SITE DEVELOPMENT PLAN
HOPE PHYSICAL THERAPY-PARKING LOT
THIRTEEN OUTLAWS, LLC
4850 AUSTIN BLUFFS PKWY
COLORADO SPRINGS, CO 80918

HORIZONTAL CONTROL

C1.0
Sheet 2 of 8

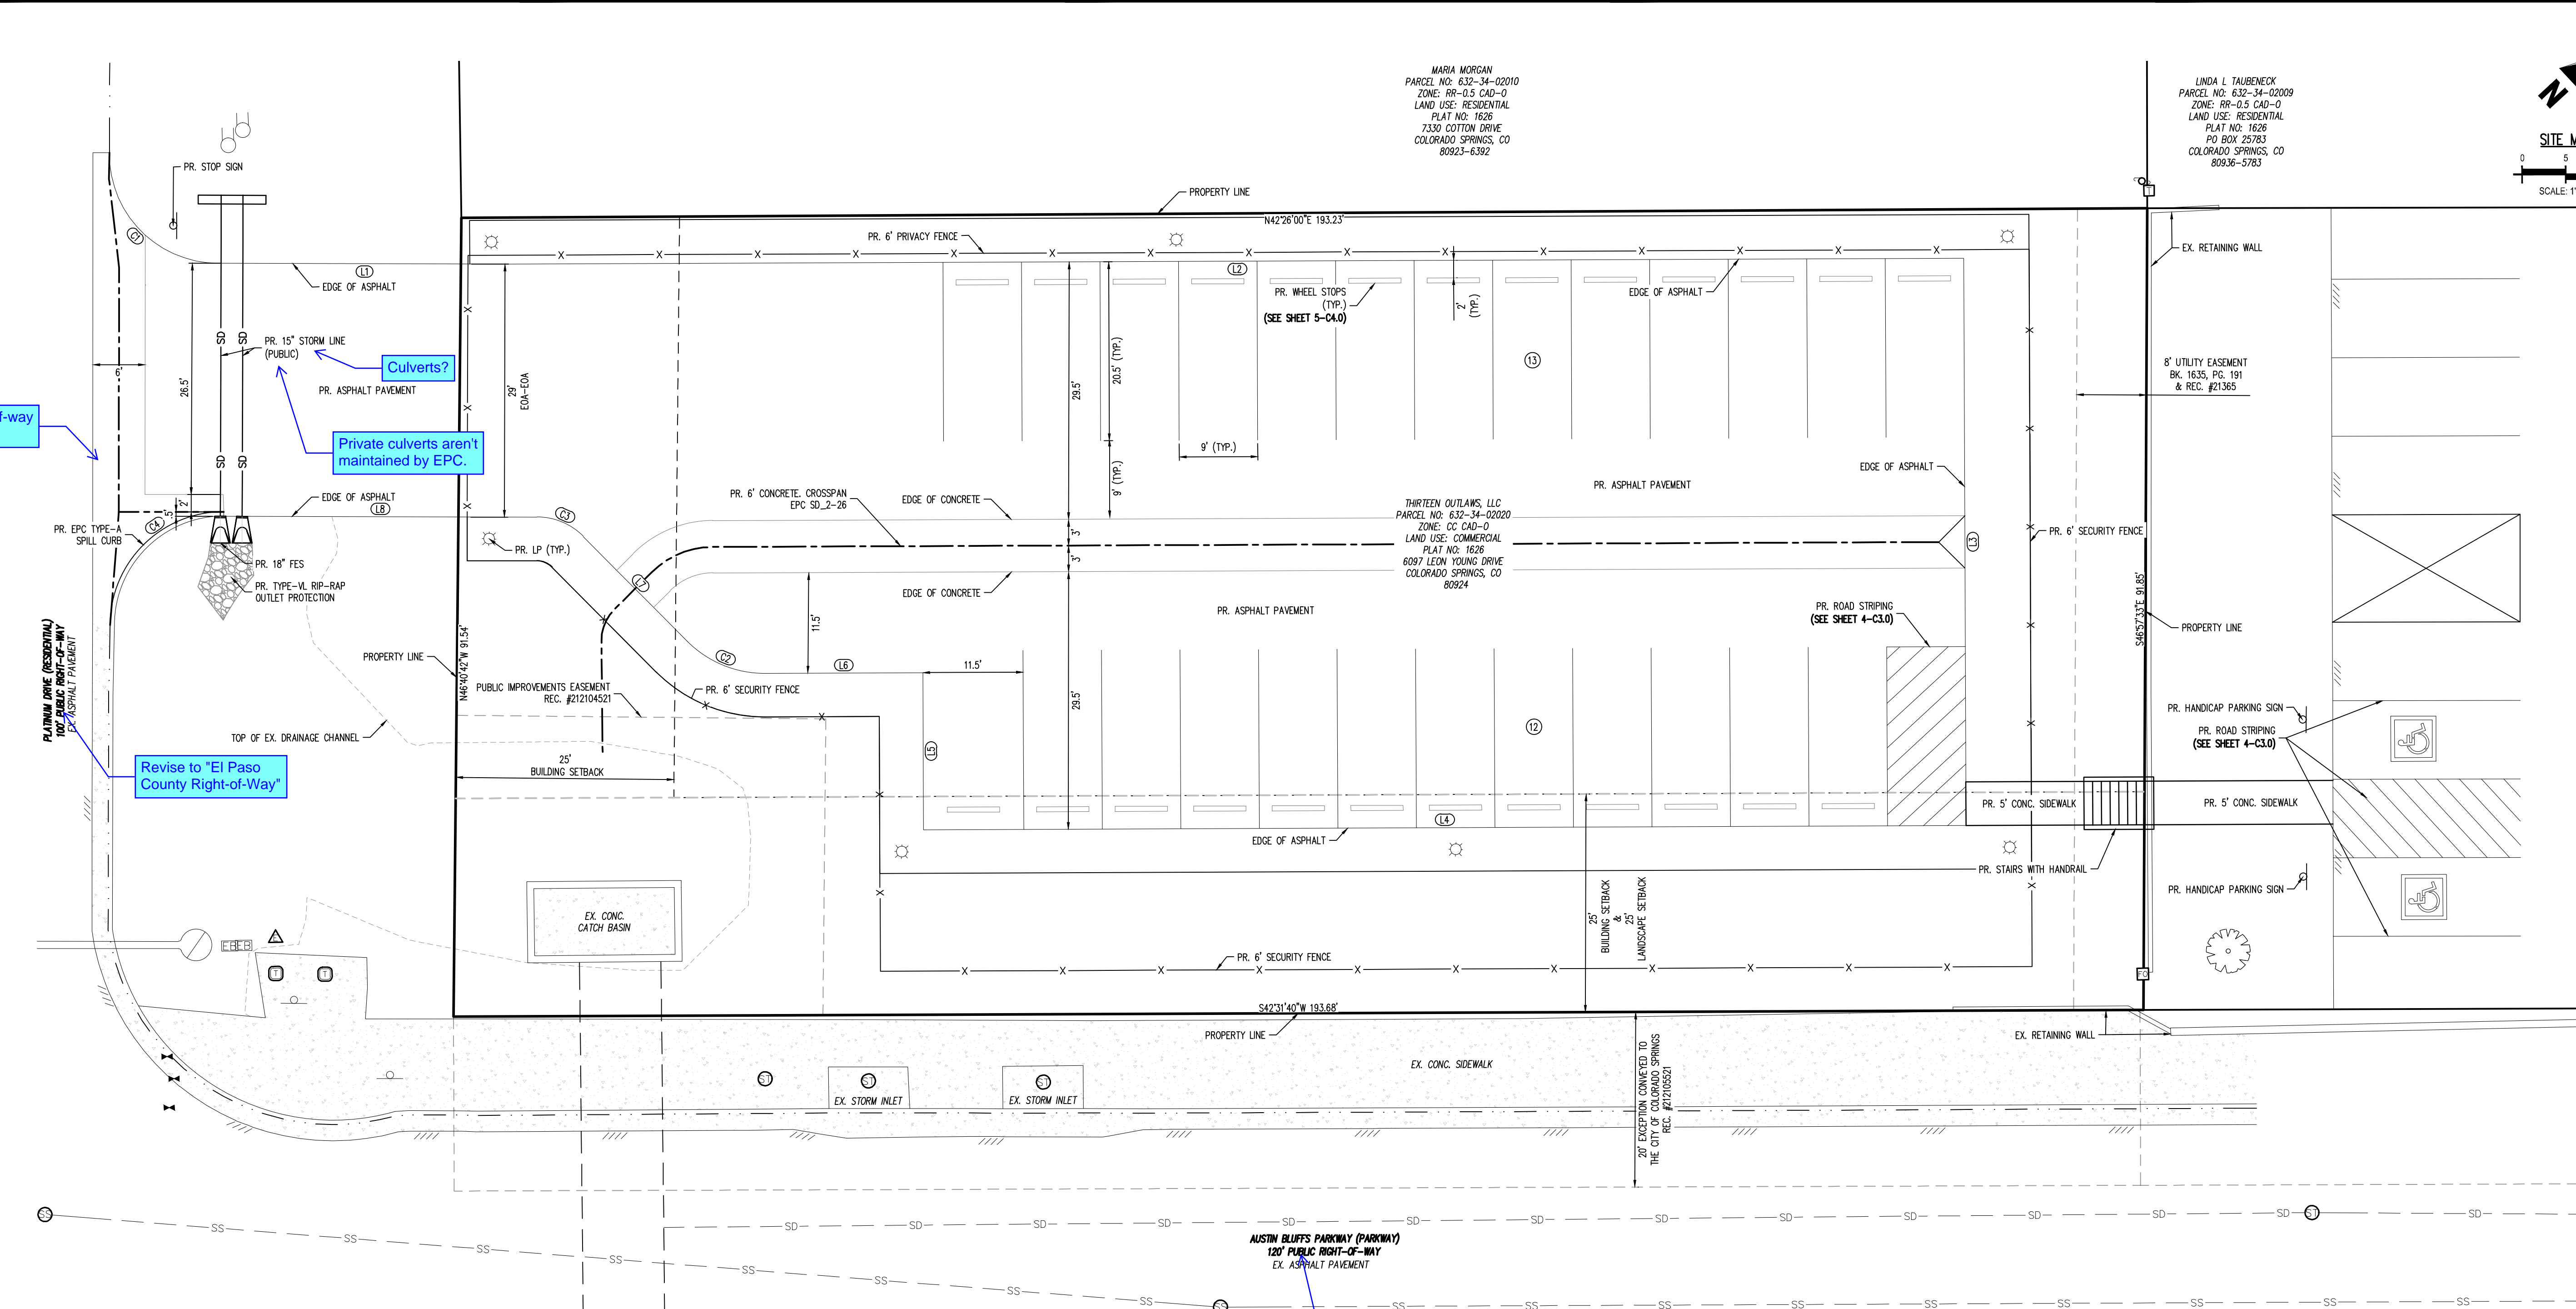
Label right-of-way line

Private culverts aren't maintained by EPC.

Revise to "El Paso County Right-of-Way"

Revise to "City of Colorado Springs Right-of-Way"

SIGNAGE & STRIPING

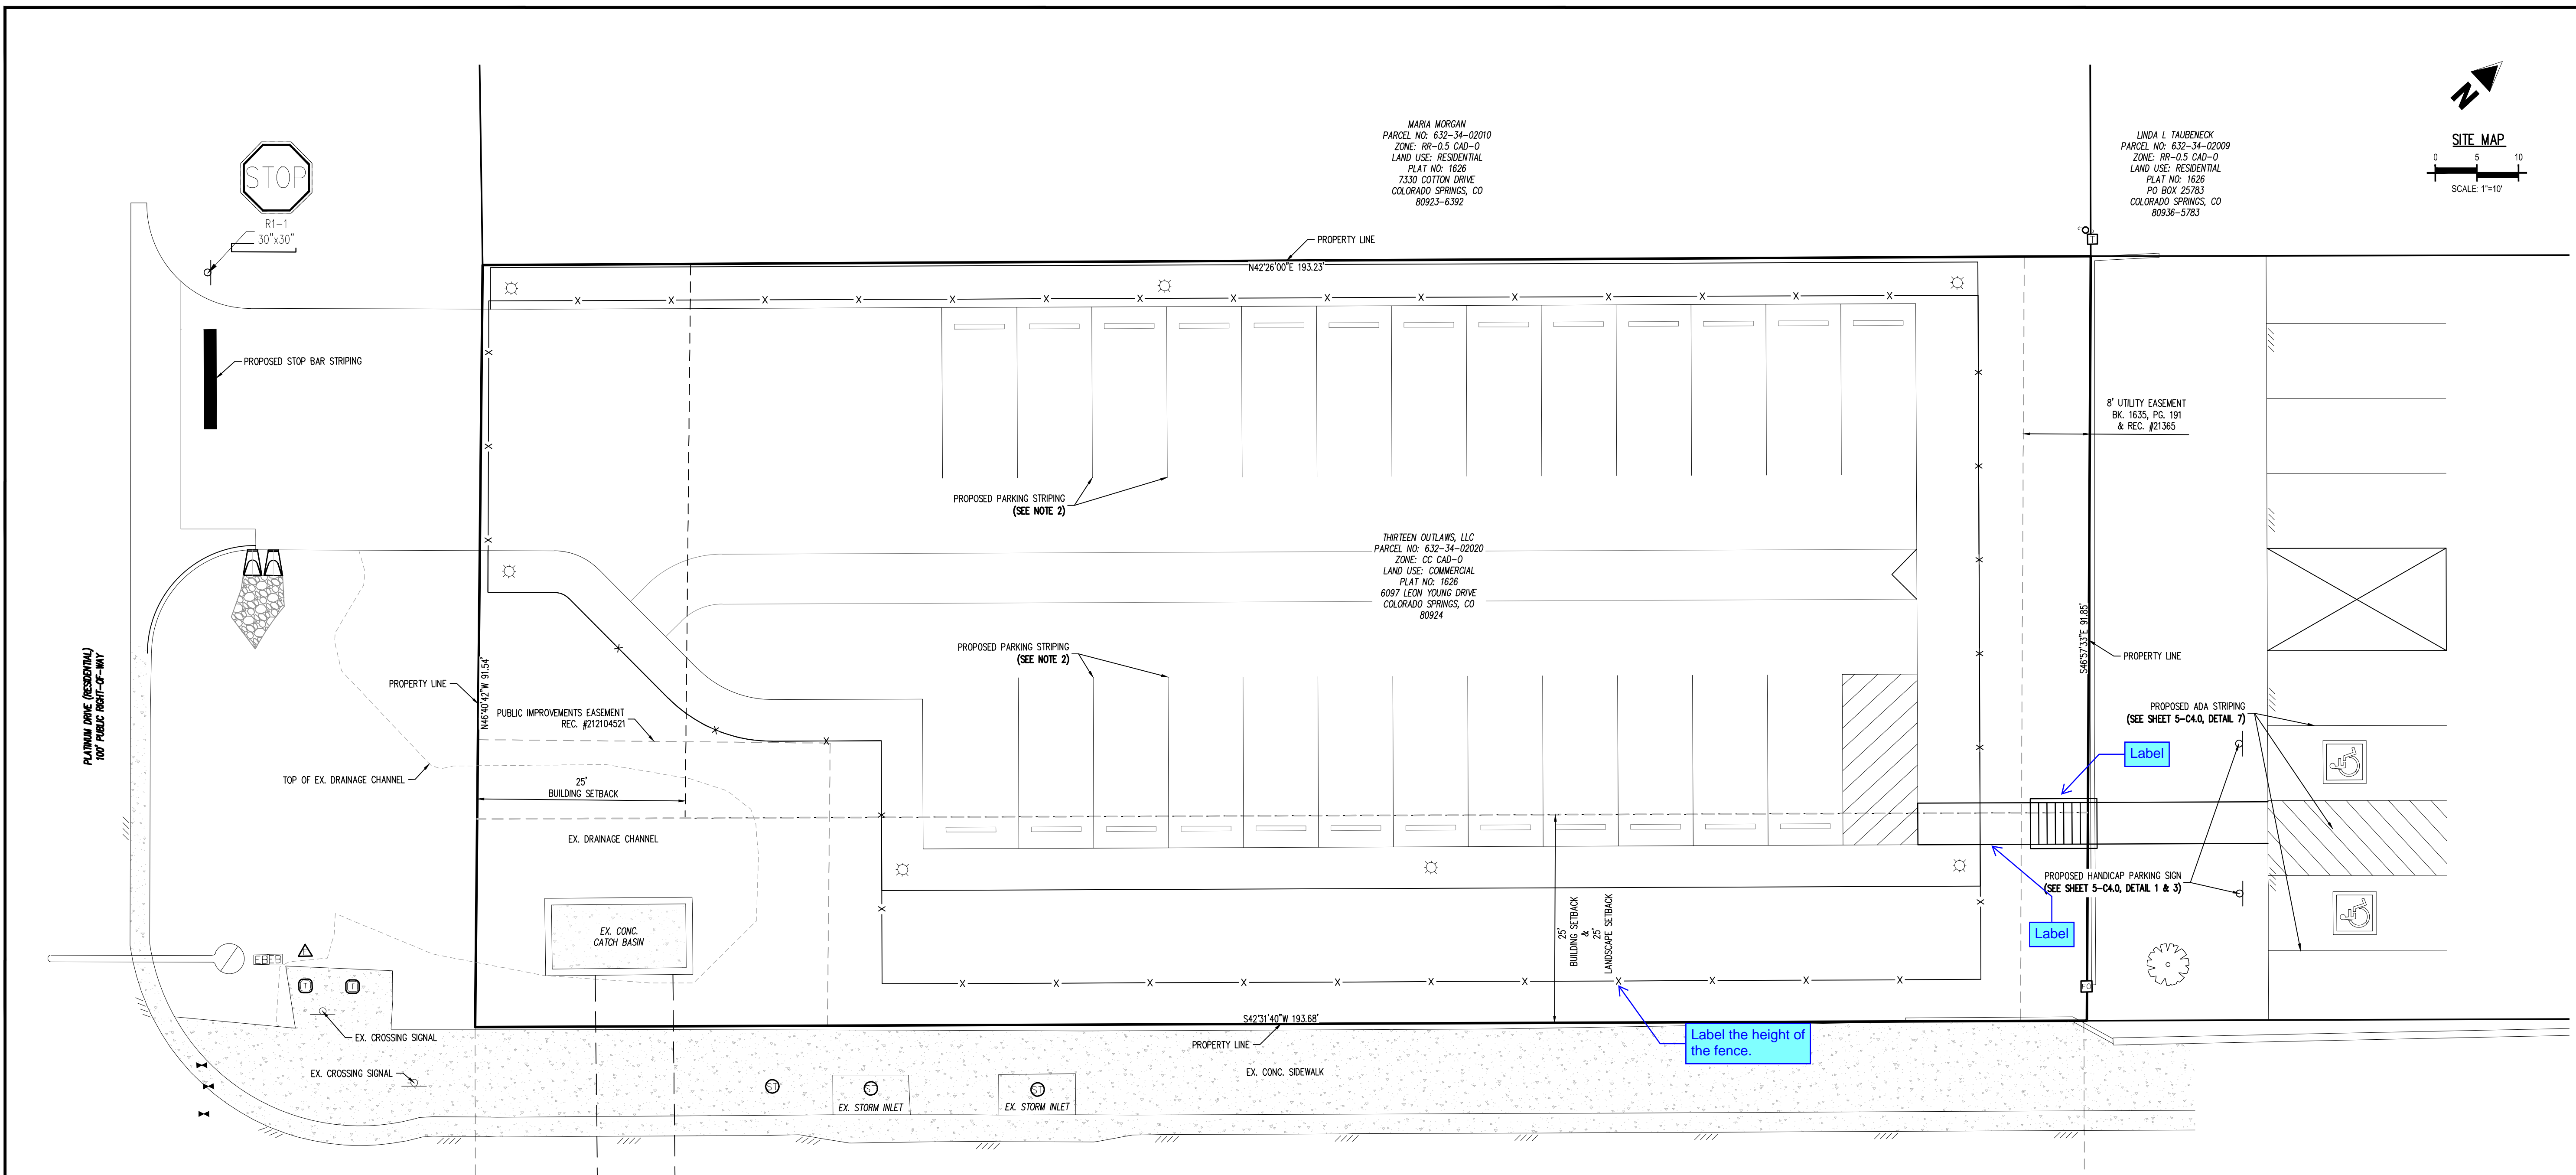
Please clearly label where ADA and handicapped parking spots will be.

6.1.3. Americans with Disabilities Act (ADA) Site Accessibility

(A) Compliance. Compliance with the ADA and other Federal and State accessibility laws is the sole responsibility of the property owner. Therefore, compliance with this Code does not assure compliance with ADA or any other Federal or State accessibility laws or any other regulations or guidelines enacted or promulgated under or with respect to such laws. El Paso County is not responsible for enforcement of the ADA or any other Federal or State accessibility laws.

(B) Notes on Site Development Plan or Non-Residential Site Plan. The following note should be added to all site development plans or non-residential site plans, as applicable, prior to PCID approval:
 The parties responsible for this plan have familiarized themselves with all current accessibility criteria and specifications and the proposed plan reflects all site elements required by the applicable ADA design standards and guidelines as published by the United States Department of Justice. Approval of this plan by El Paso County does not assure compliance with the ADA or any regulations or guidelines enacted or promulgated under or with respect to such laws.

(C) Illustrated on Site Development Plan or Non-Residential Site Plan. Each site development plan or non-residential site plan submitted to El Paso County shall clearly illustrate and identify the provision of ADA accessible exterior routes in accordance with the applicable ADA design standards and guidelines as published by the United States Department of Justice.
